INDESIT company

AVXXF129/1EX

F039127

1200150 Exploded views

1200150B

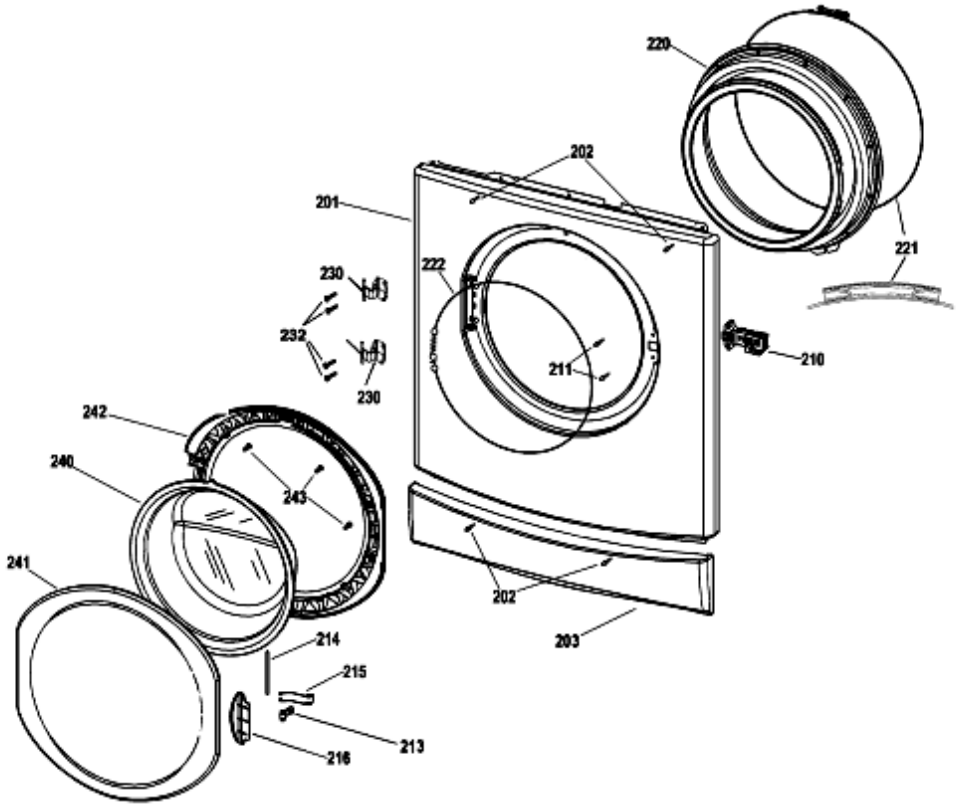
n4008d03: Change of Suspension Mounting Bracket

From serial number 80317.0001 all 7Kg split drum WM & 6 Kg WD’s, and from serial number 80411.0001 6Kg all welded drum WM’s the suspension damper mounting bracket changed in production from a screw fixing from outside of the cabinet base to a screw fixing from the inside of the cabinet base.

The two versions of mounting bracket are not interchangeable.

The damper assembly will now be supplied with the later version of mounting bracket and when changing a suspension unit to a machine produced prior to 80317.0001 & 80411.0001 it will be necessary to transfer the brackets from the old to the new unit.

1200230 Exploded views

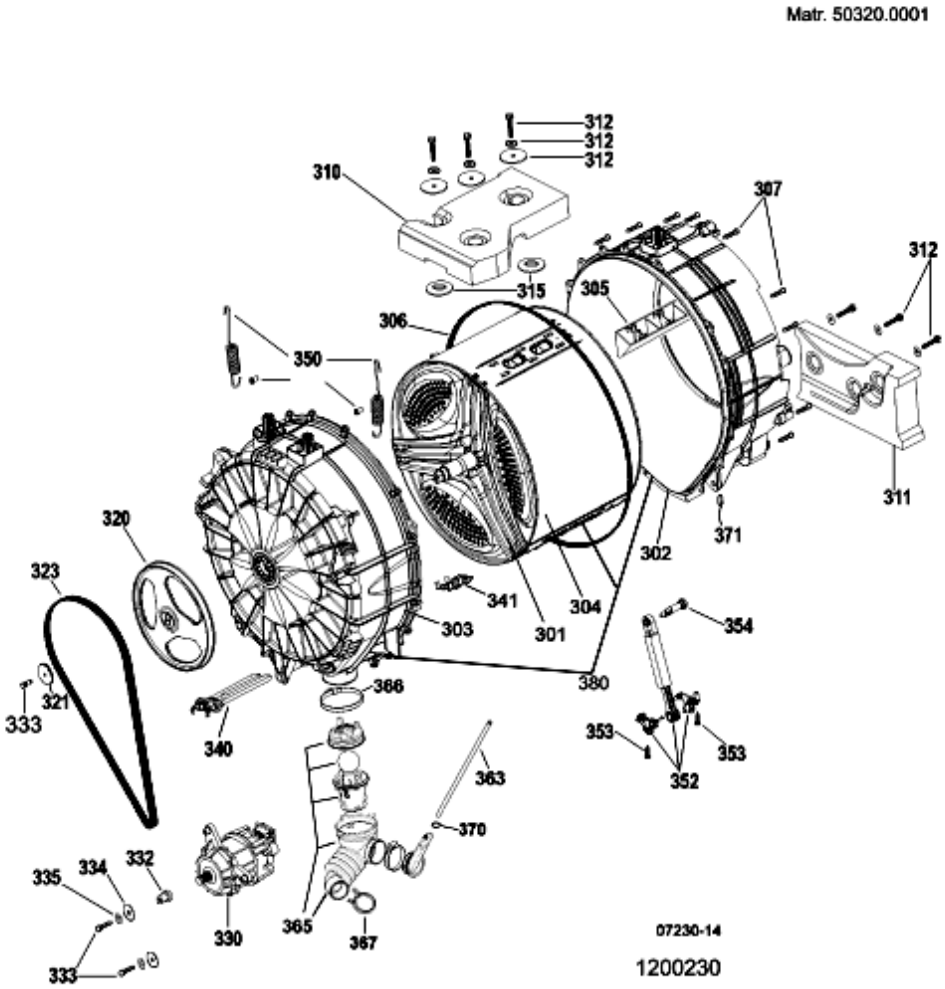
n4008b01: DRUM KIT CONTENTS

This Kit contains the following items:

Drum - Bearings / Seal fitted
Drum Seal
Heating Element
Plastic Damper Pegs x2

1200350 Exploded views

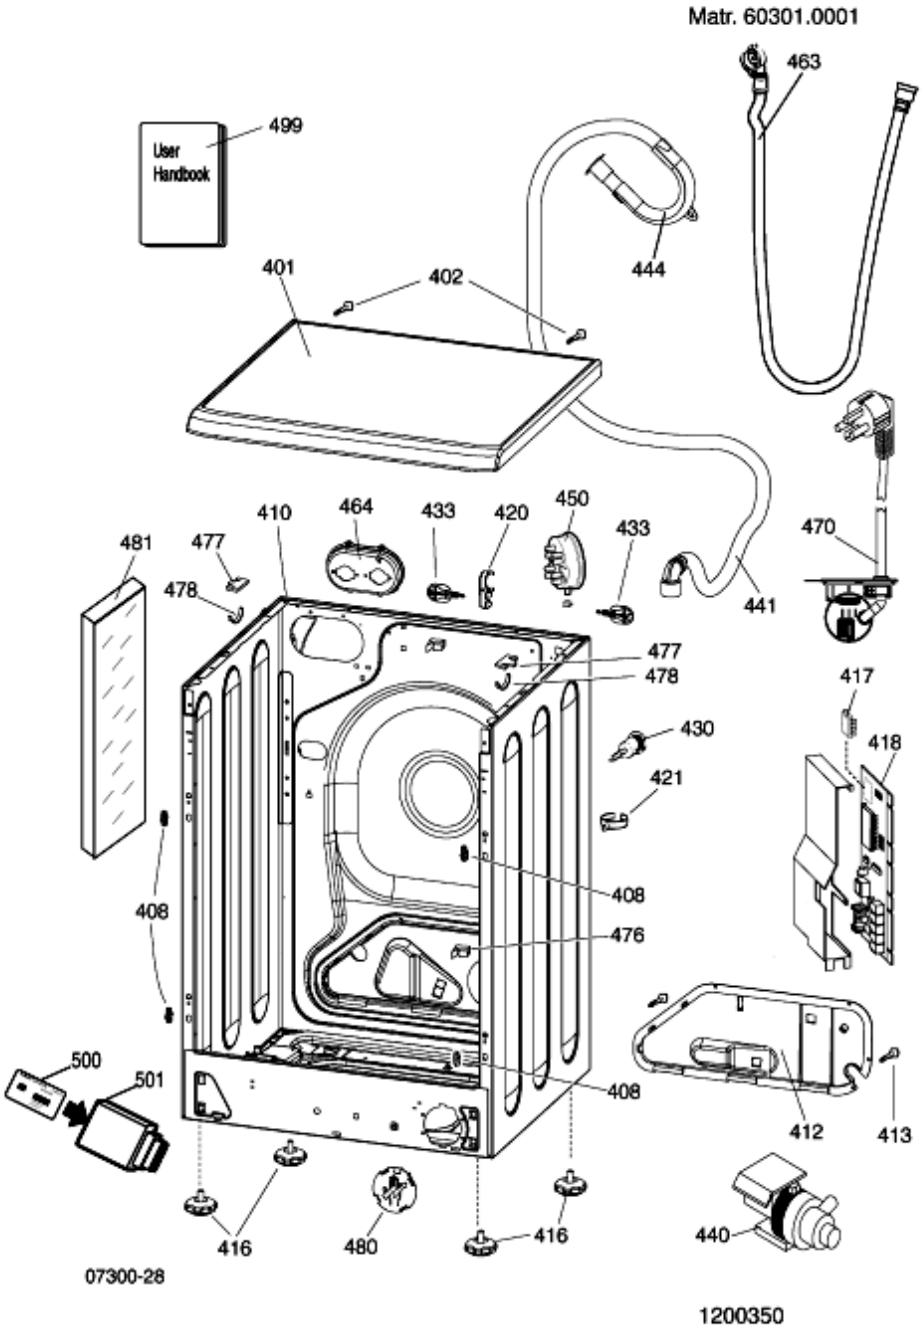
n4008e00: Suspension fixing to cabinet

From serial number 80317.0001 all 7Kg split drum WM & 6 Kg WD’s, and from serial number 80411.0001 6Kg all welded drum

WM’s the suspension damper mounting bracket changed in production from a screw fixing from outside of the cabinet base to a screw fixing from the inside of the cabinet base.

The two versions of mounting bracket are not interchangeable.

Both the cabinet and damper assembly will now be supplied with the later version of mounting bracket and when replacing a cabinet or to machine produced before serial number 80317.0001 & 80411.0001 as listed above, it will be necessary to also fit new suspension units and fixing screws.
